# HISTORIC AND DESIGN REVIEW COMMISSION

July 06, 2018

**HDRC CASE NO:** 2018-303  
**COMMON NAME:** Print Building  
**ADDRESS:** 420 BROADWAY  
**LEGAL DESCRIPTION:** NCB 432 (SAN ANTONIO LIGHT), BLOCK 16 LOT 14  
**ZONING:** FBZ T6-1, HS, RIO-2  
**CITY COUNCIL DIST.:** 1  
**LANDMARK:** San Antonio Light Building  
**APPLICANT:** Peter French/Gray Street Partners  
**OWNER:** Graystreet 420 Broadway LLC  
**TYPE OF WORK:** Exterior modifications to the Print Building and the construction of a connector addition to the Light Building  
**APPLICATION RECEIVED:** June 15, 2018  
**60-DAY REVIEW:** August 14, 2018  
**REQUEST:**

## WEST ELEVATION

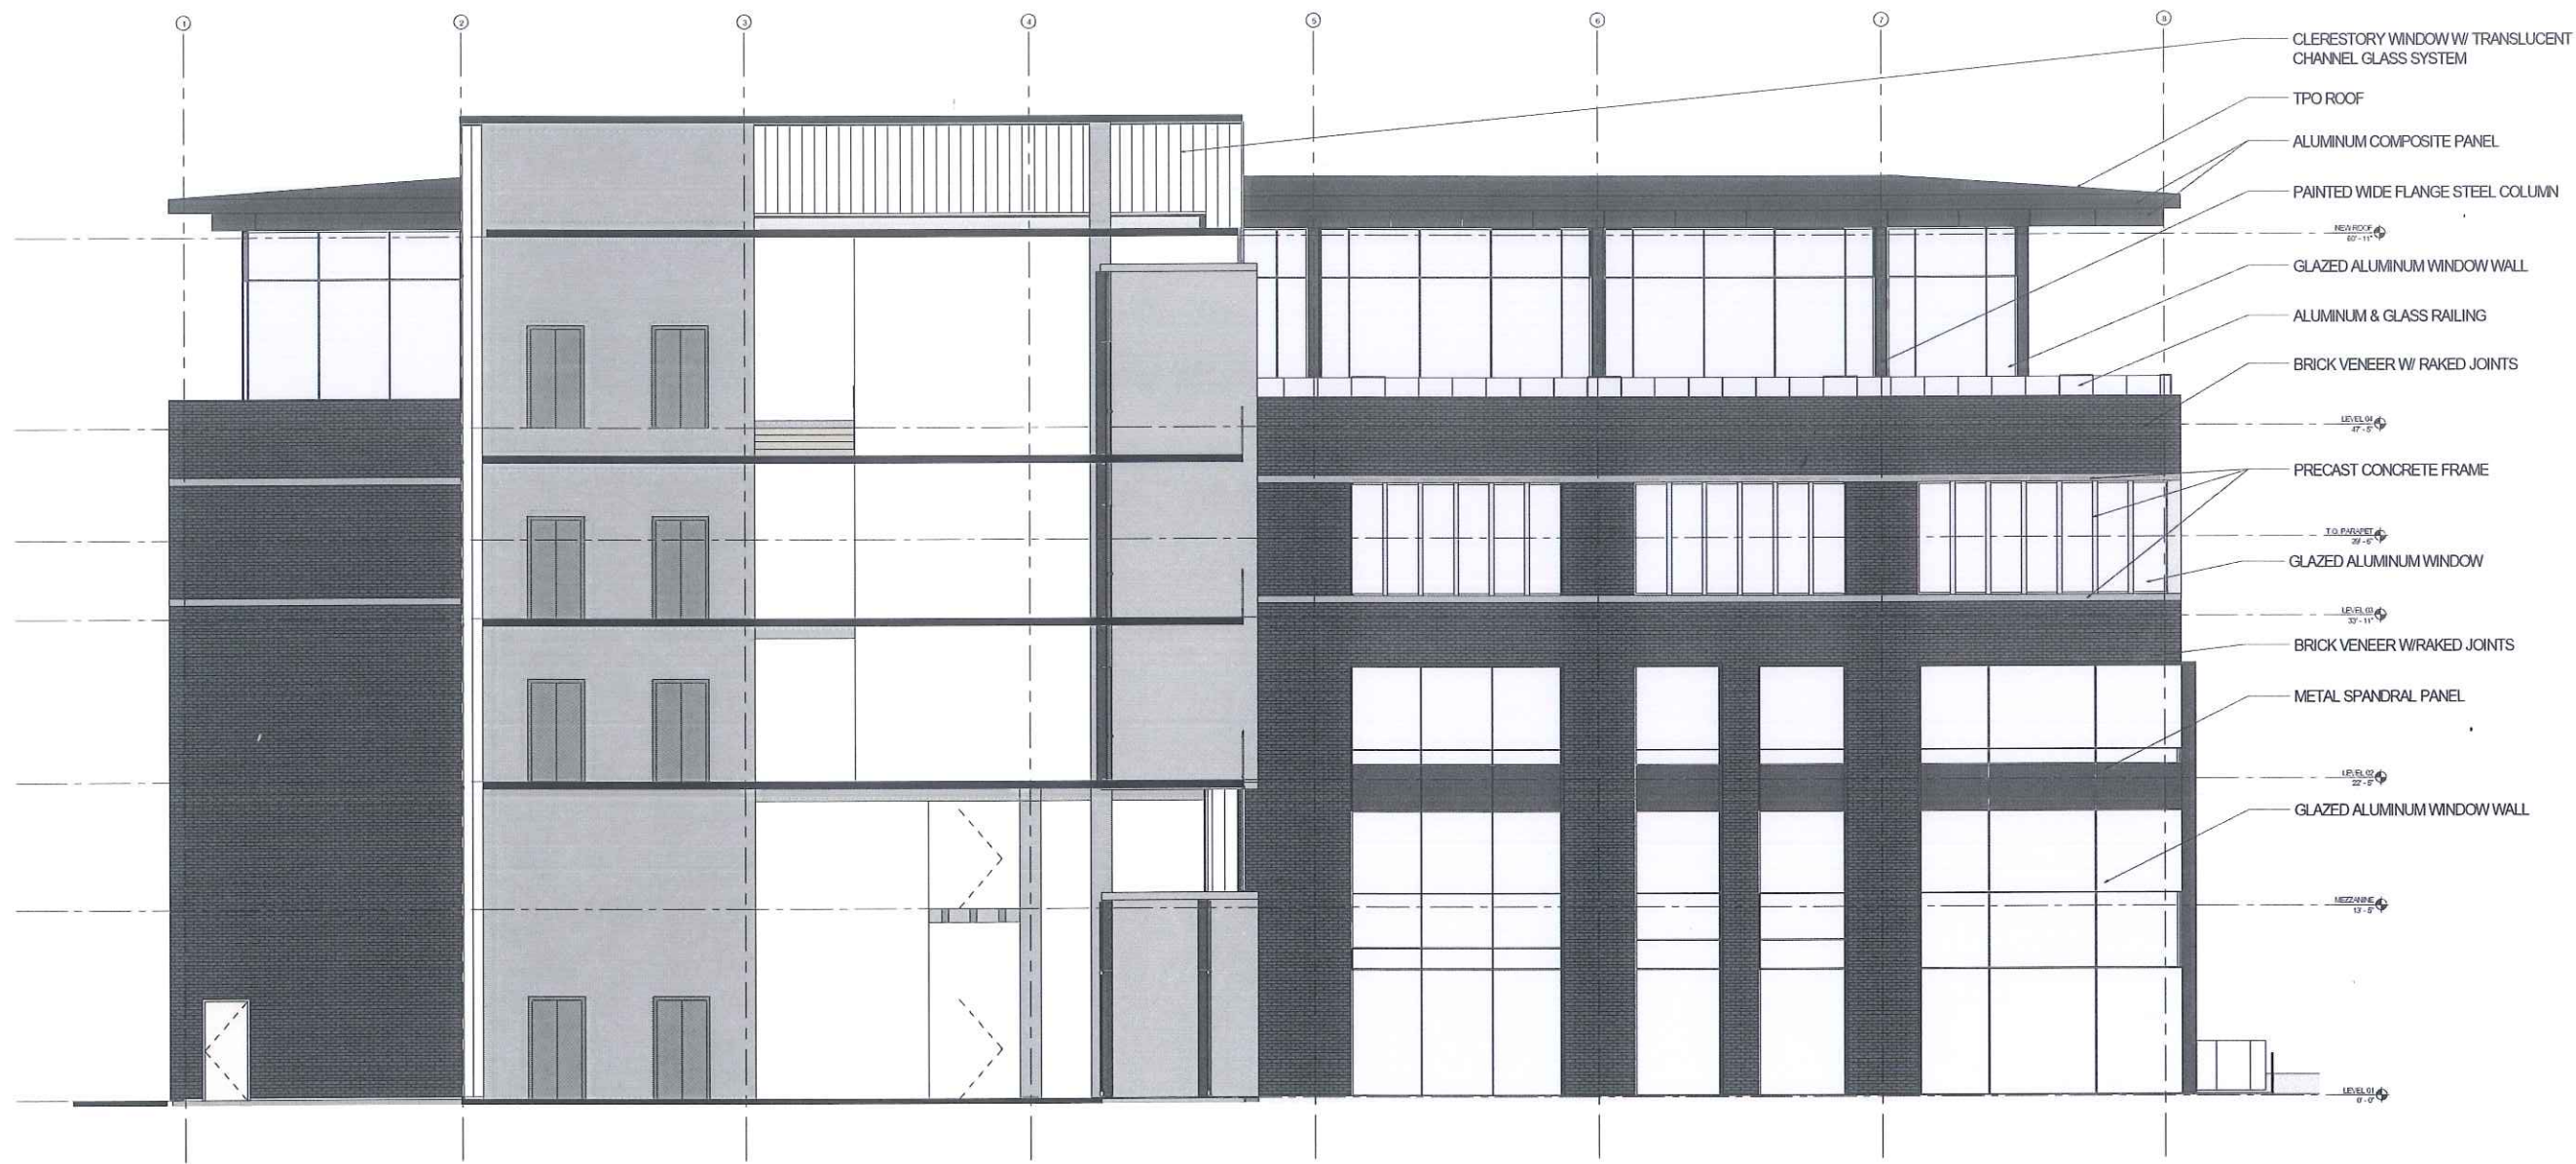
- f. **PRINT BUILDING MODIFICATIONS** – The Print Building currently features a tan brick façade with fenestration patterns framed by cast stone. The proposed modifications to the exterior of the structure would result in the removal of the structure’s currently fenestration pattern, brick and façade arrangement. The UDC Section 35-676 notes that every reasonable effort shall be made to adapt the property in a manner which requires minimal alteration of the building, structure, object, or site and its environment. The UDC also notes that the distinguishing original qualities or character of a building, structure, object, or site and its environment, shall not be destroyed. Per the Historic Design Guidelines, Guidelines for Exterior Maintenance and Alterations 10.A., character defining features of structures zoned historic should be preserved. The removal or alteration of any historic material or distinctive architectural features shall be avoided. Staff finds that the proposed façade modifications remove the distinguishing original qualities and character of the building and are not consistent with the Historic Design Guidelines and the UDC.

- g. **PRINT BUILDING MODIFICATIONS** – As noted in finding f, character defining features should be preserved. The Guidelines for Exterior Maintenance and Alterations 10.B.i. notes that new features should not be introduced that alter or destroy the historic building character, such as such as adding inappropriate materials; altering the size or shape of windows, doors, bulkheads, and transom openings; or altering the façade from commercial to residential. Staff finds that the proposed modifications are inconsistent with the Guidelines.

- h. **PRINT BUILDING ADDITION** – The applicant has proposed an addition of two levels to the rooftop of the Print Building. The UDC Section 35-676 notes that new additions shall be done in such a manner that if such additions or alterations were to be removed in the future, the essential form and integrity of the building or structure would be unimpaired. Staff finds that the proposed addition’s massing and overall form are appropriate; however, the addition should feature an overall form and design that complements to existing architectural features of the building. Currently, the addition’s design is consistent with the proposed modifications, which are not consistent with the UDC.

1. Staff does not recommend conceptual approval of item #1, exterior modifications to the Print Building based on findings f and g. Staff recommends that the applicant adhere to the UDC and modify the structure within the existing design.

2. Staff does not recommend conceptual approval of item #2, the proposed rooftop addition based on finding h. Staff finds that an addition may be appropriate; however, the addition should feature an overall form and design that complements to existing architectural features of the building. Currently, the addition's design is consistent with the proposed modifications, which are not consistent with the UDC.

3D VIEW - SOUTHWEST

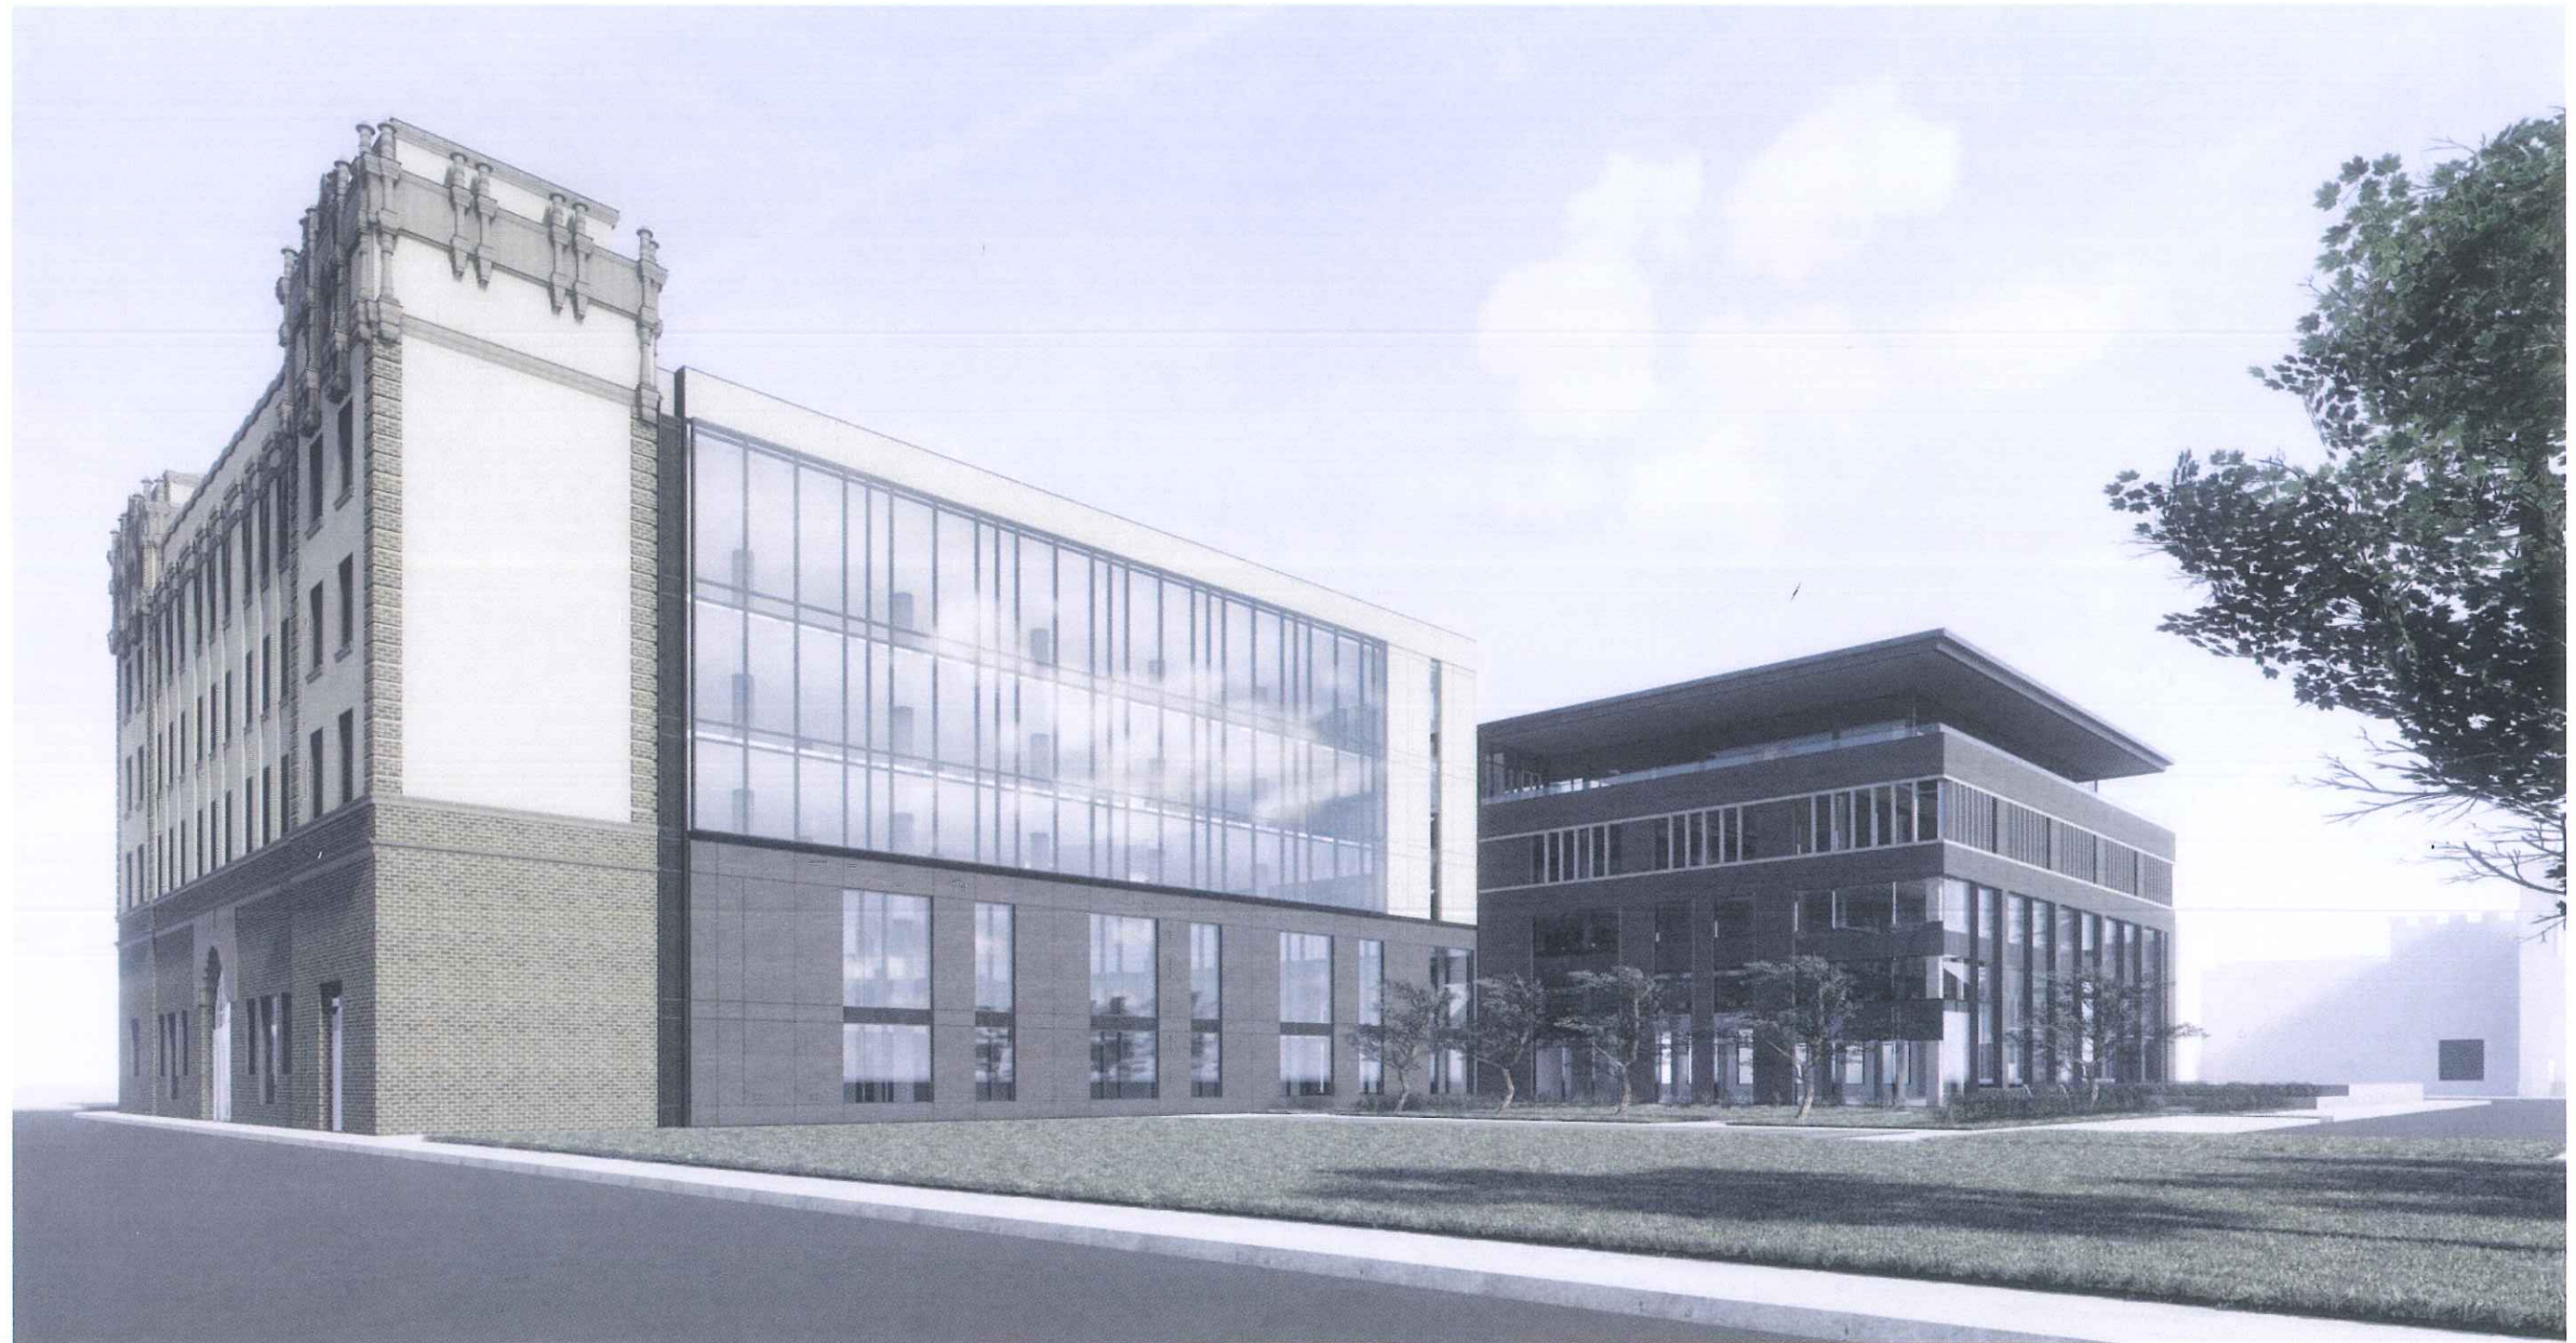
- d. **CONNECTOR ADDITION** – At the rear of the Light Building, the applicant has proposed to remove the existing sky bridge and construct a vertical connector to join the Light Building to the Print Building. Per the Guidelines for Additions, additions to non-residential structures should be located at the rear of the historic structure, should not lessen the historic character of the historic building when viewed from the public right of way, should feature a similar roof form, should be subordinate to the principal façade and should be subordinate in height to the primary historic structure. While the proposed connector addition features a height that exceeds that of the Light Building, staff finds that the overall design given its setbacks from the historic facades and simplified design may be appropriate.

- e. **CONNECTOR ADDITION** – The applicant has proposed materials that include a translucent channel glass system, a glazed aluminum curtain wall system and aluminum and glass railings. Staff finds that through the use of translucent, non-masonry materials, the connector addition is appropriate.

3. Staff recommends conceptual approval of item #3, the proposed connector addition based on findings d and e with the noted stipulation below.
4. Staff recommends conceptual approval of item #4, the construction of underground parking provided it does not negatively impact the existing facade with the noted stipulation below.
